Meeting Agenda

Historic Zoning Commission

Monday, September 11, 2023

A0.1

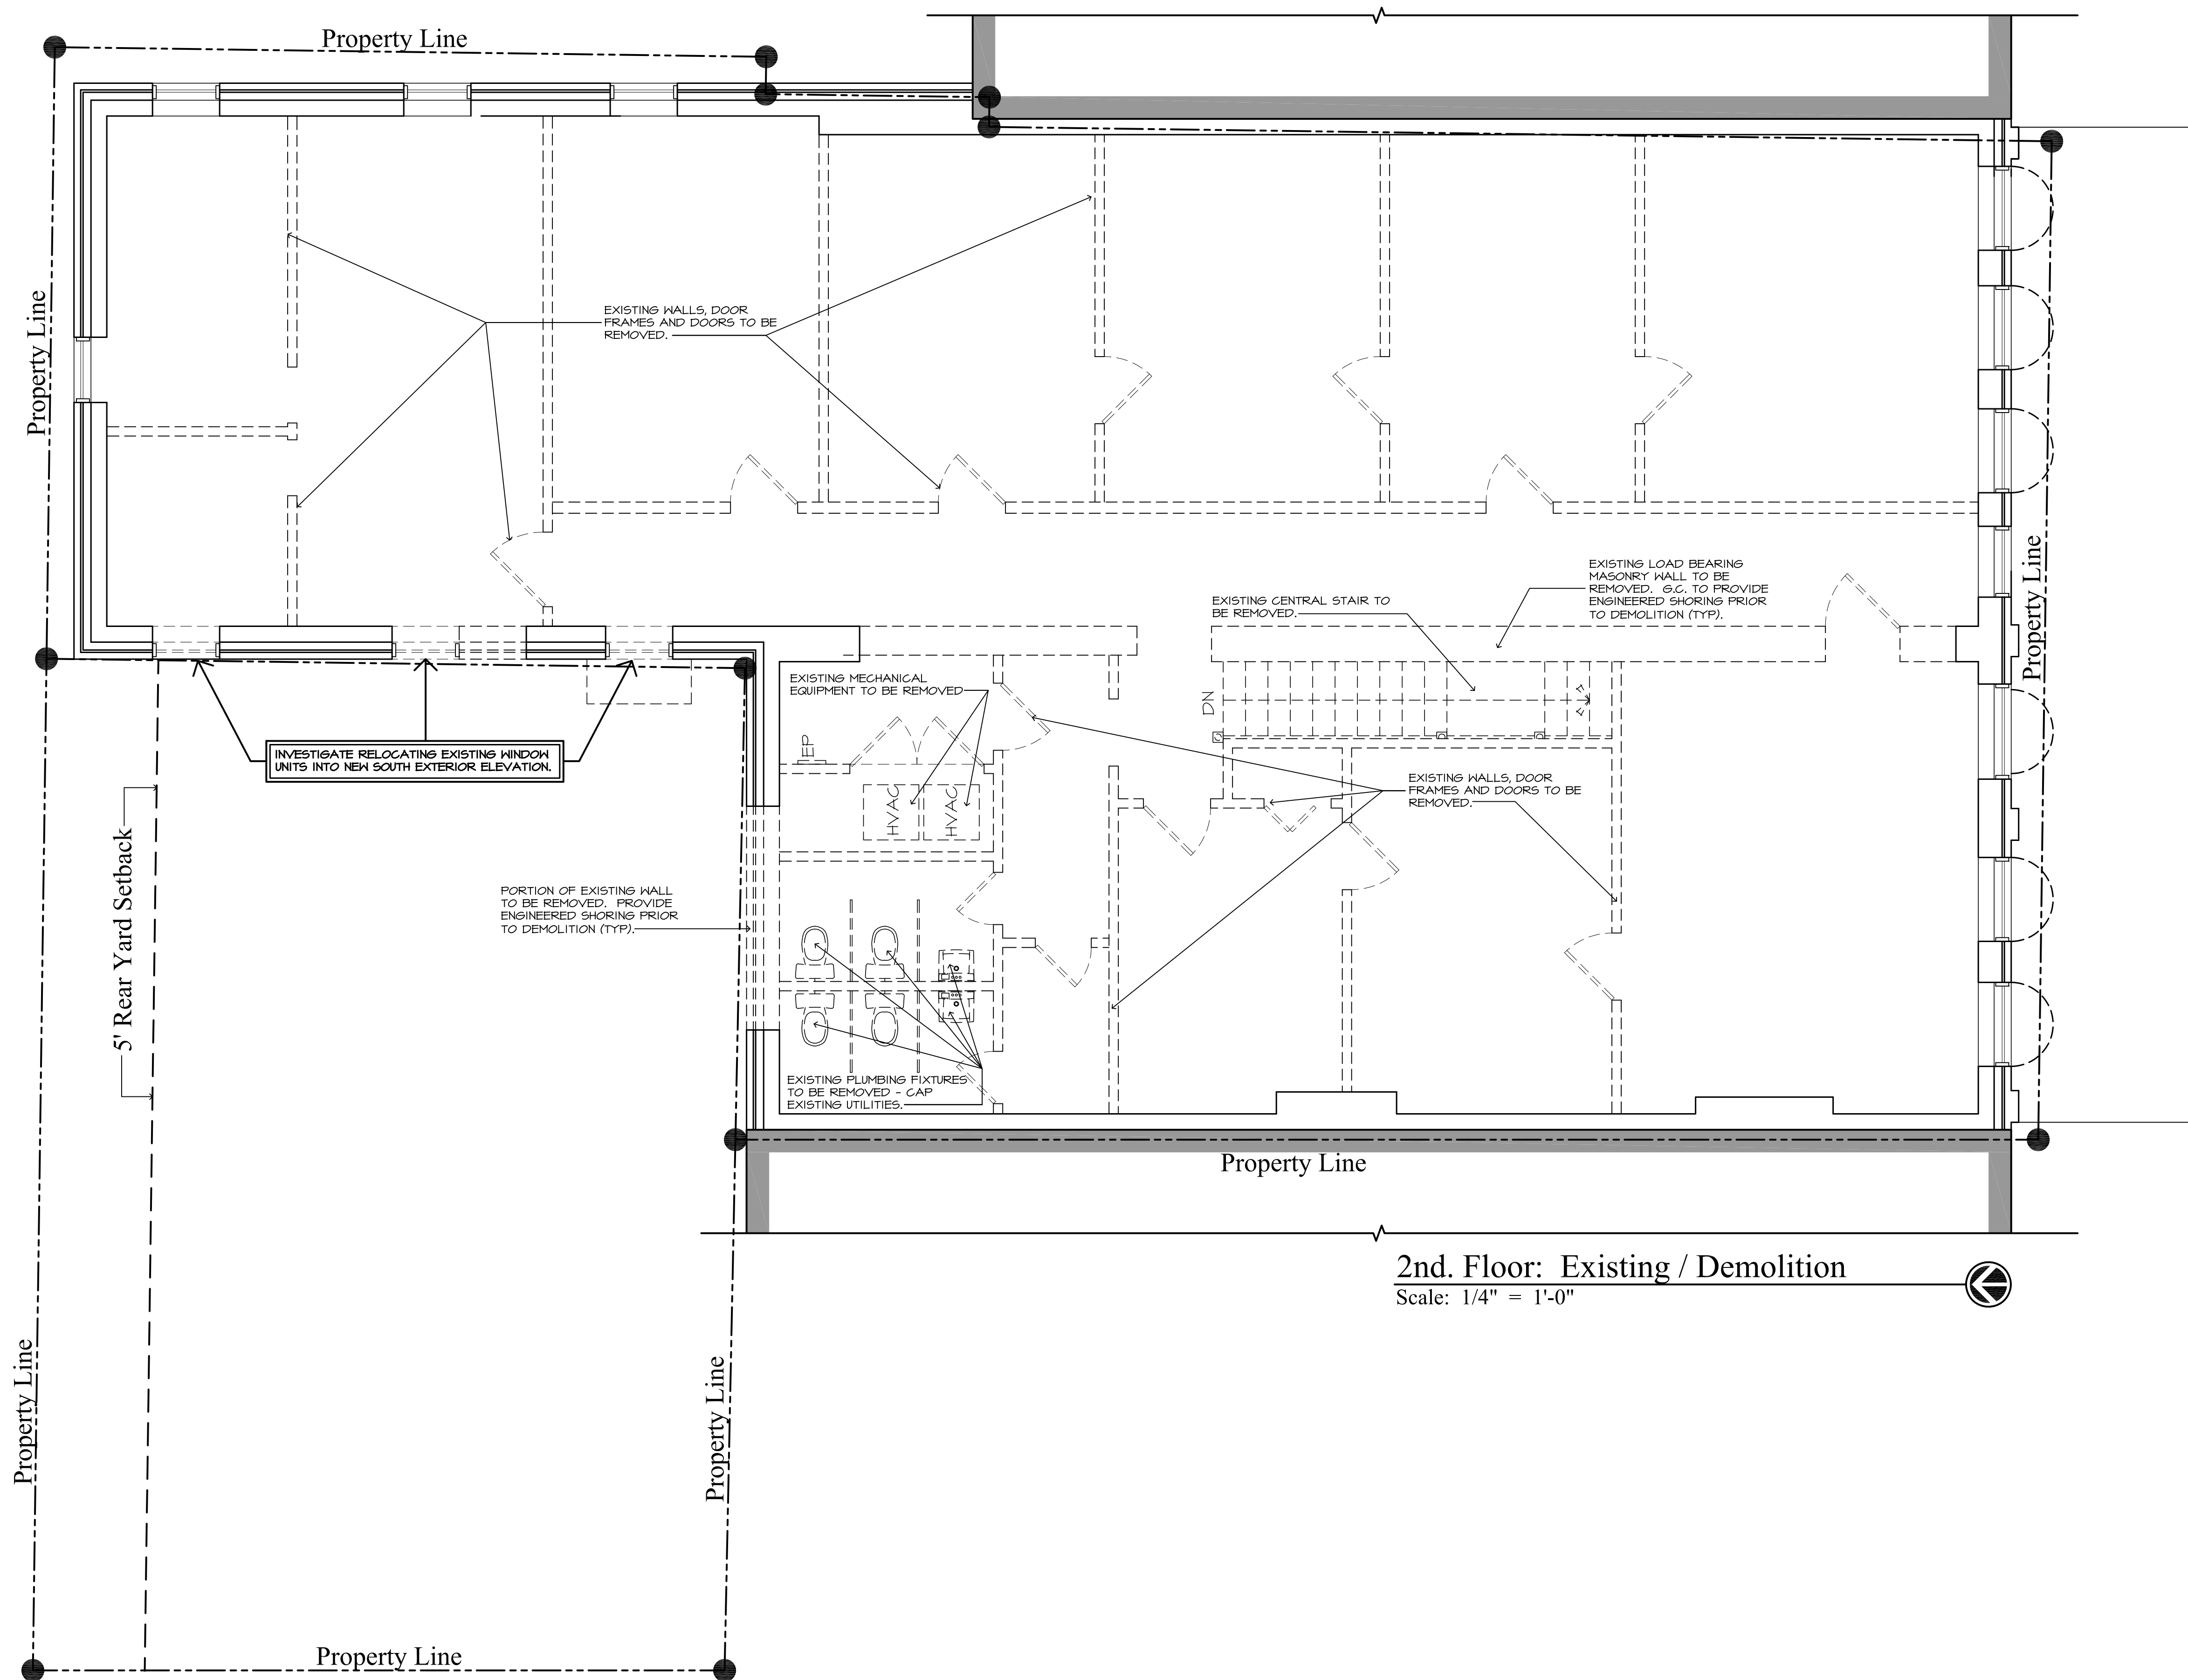
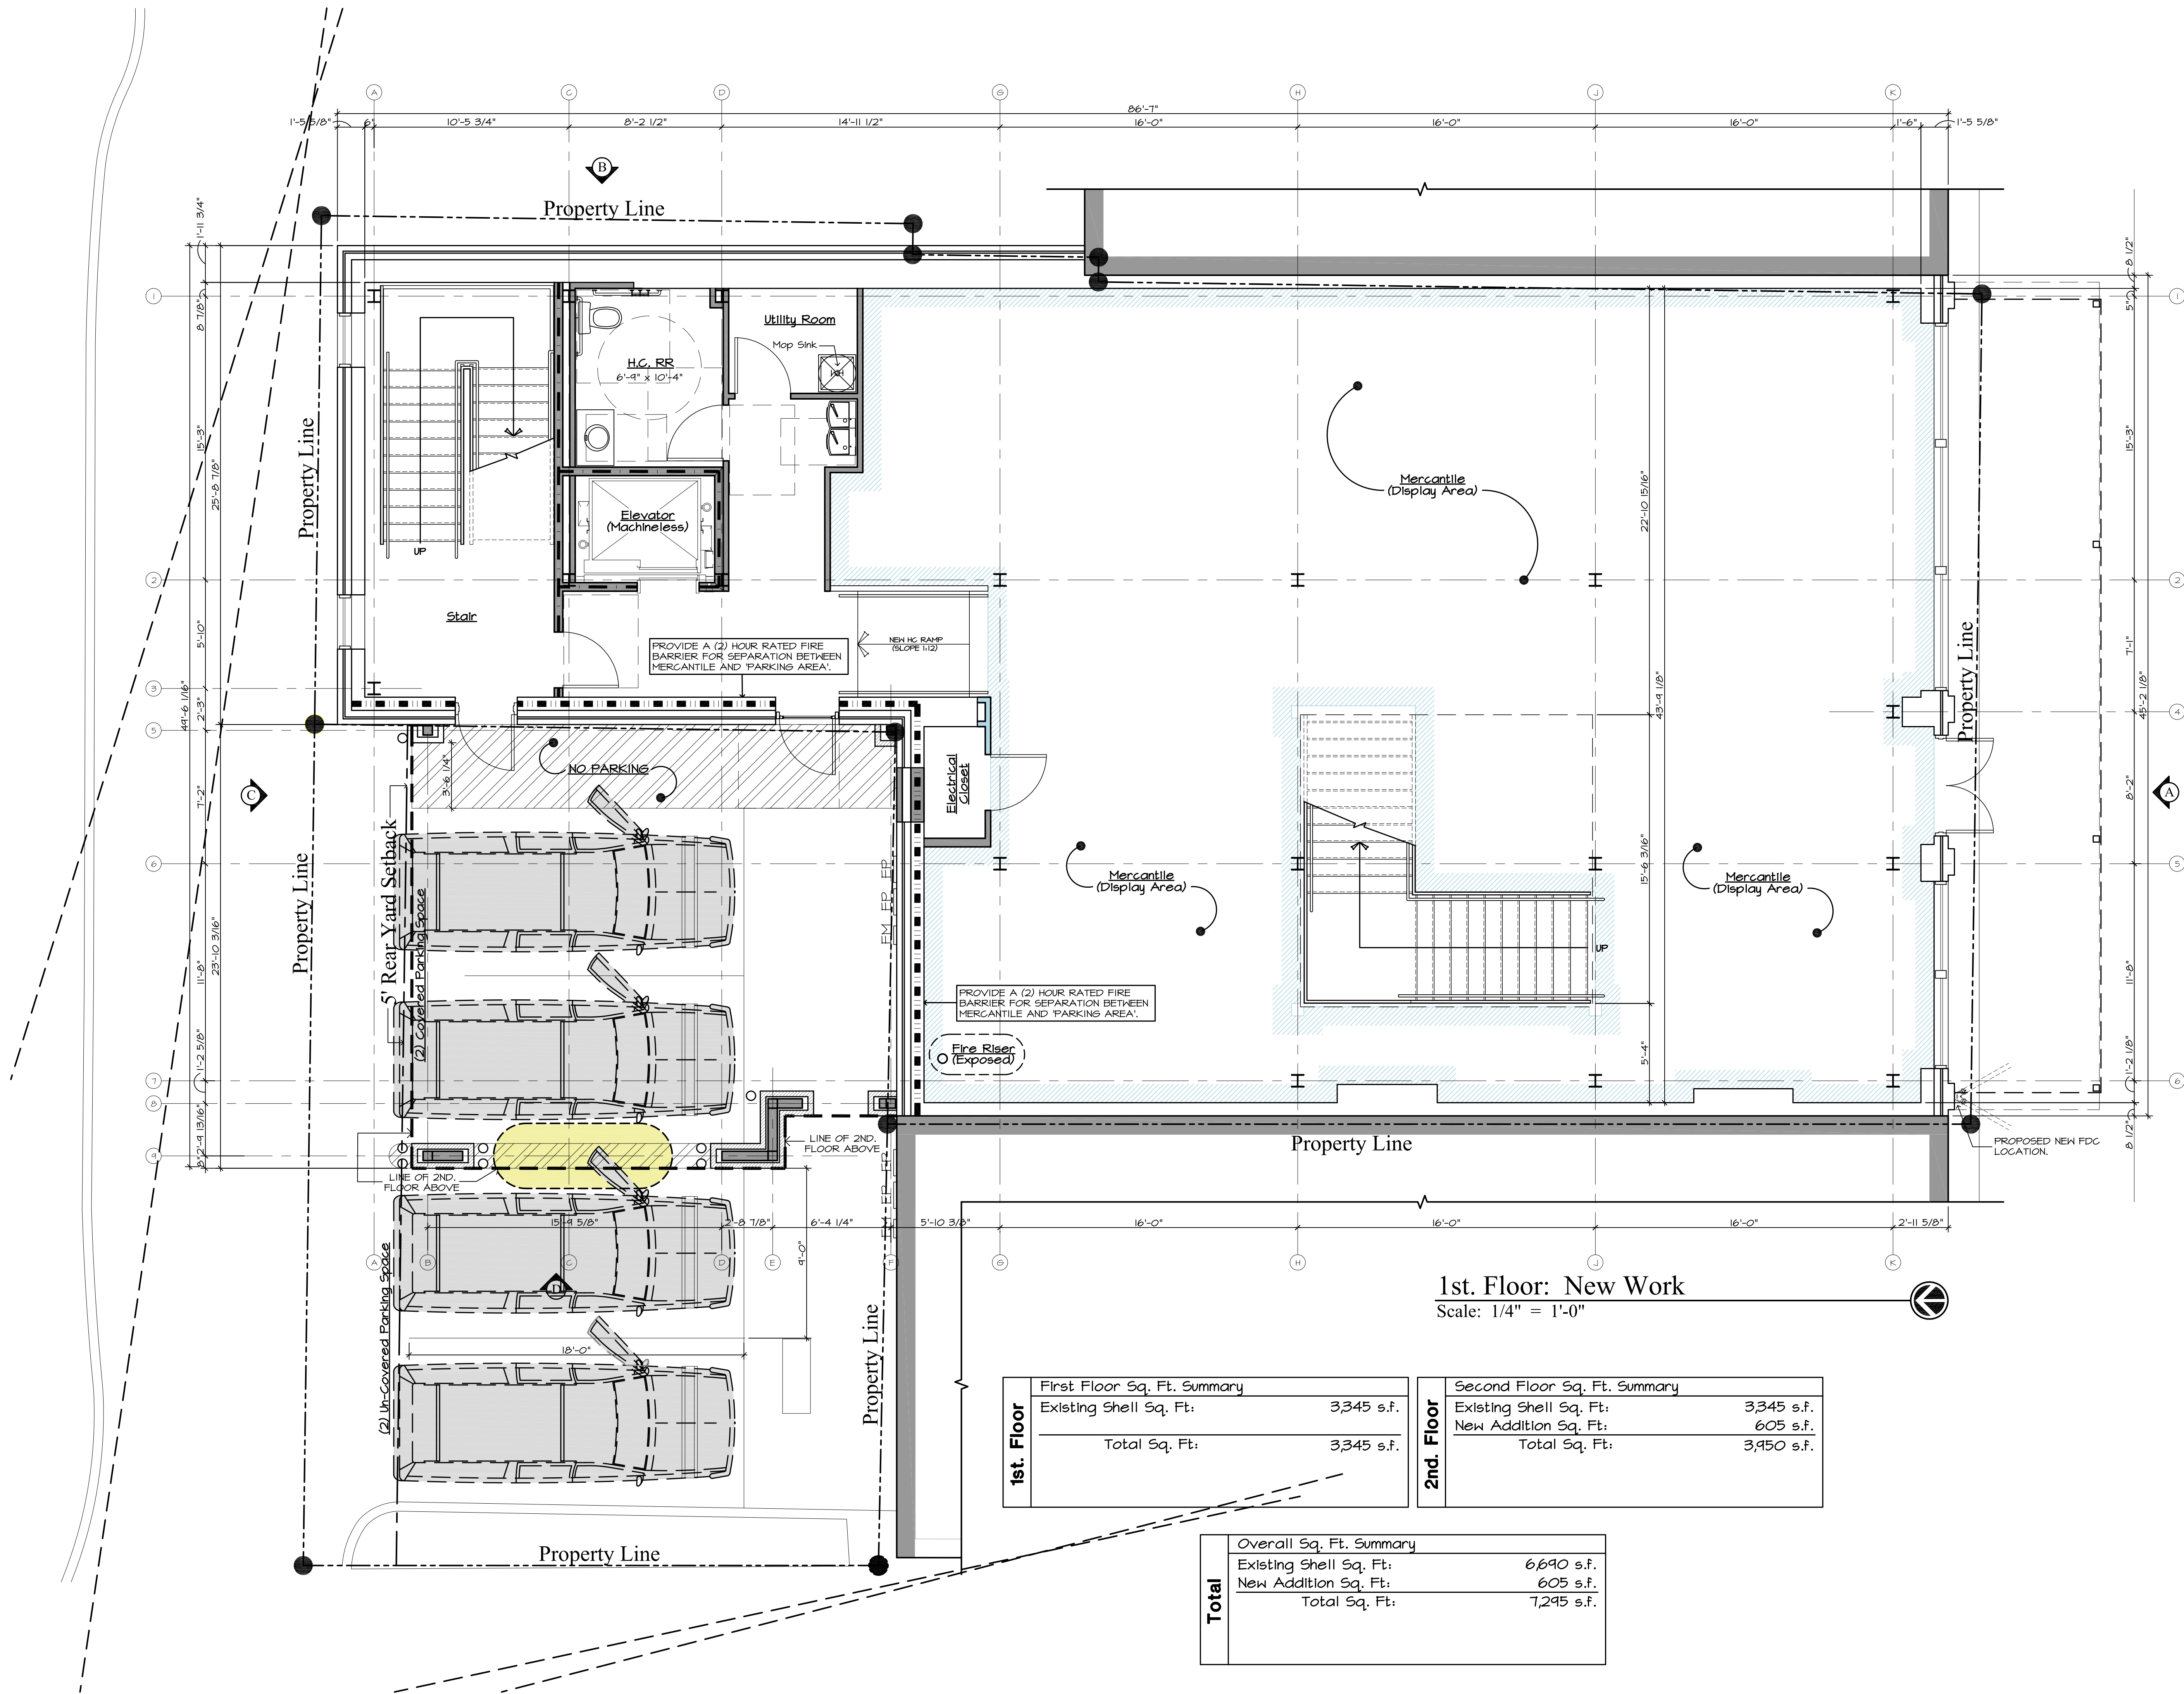
- Design additions to be subordinate in appearance to the historic building. Considerations include placement, size, massing, scale, height, setbacks, and materials.
- Avoid removal of sections of historic walls to accommodate additions unless significant structural deficiencies can be demonstrated. Design additions so that owners may remove the additions and restore the original facade if so desired.

Staff recommends denial of this application based on the following grounds:

1. Design additions to be subordinate in appearance to the historic building.
2. Avoid removal of sections of historic walls to accommodate additions unless significant structural deficiencies can be demonstrated.

1. The lots owned by the property owner must be consolidated prior to construction to be in compliance with the rear lot setback requirements.
2. The proposed brick and mortar shall match the historic brick, with a material sample of the brick and mortar subject to approval by the Preservation Planner or the Historic Zoning Commission.
3. The proposal for front door replacement shall be submitted as a separate COA application.
4. The application must meet all the requirements of the City of Franklin prior to issuance of a building permit.
5. Any additional changes to the approved plans must be returned to the Preservation Planner or the Historic Zoning Commission for review and approval.
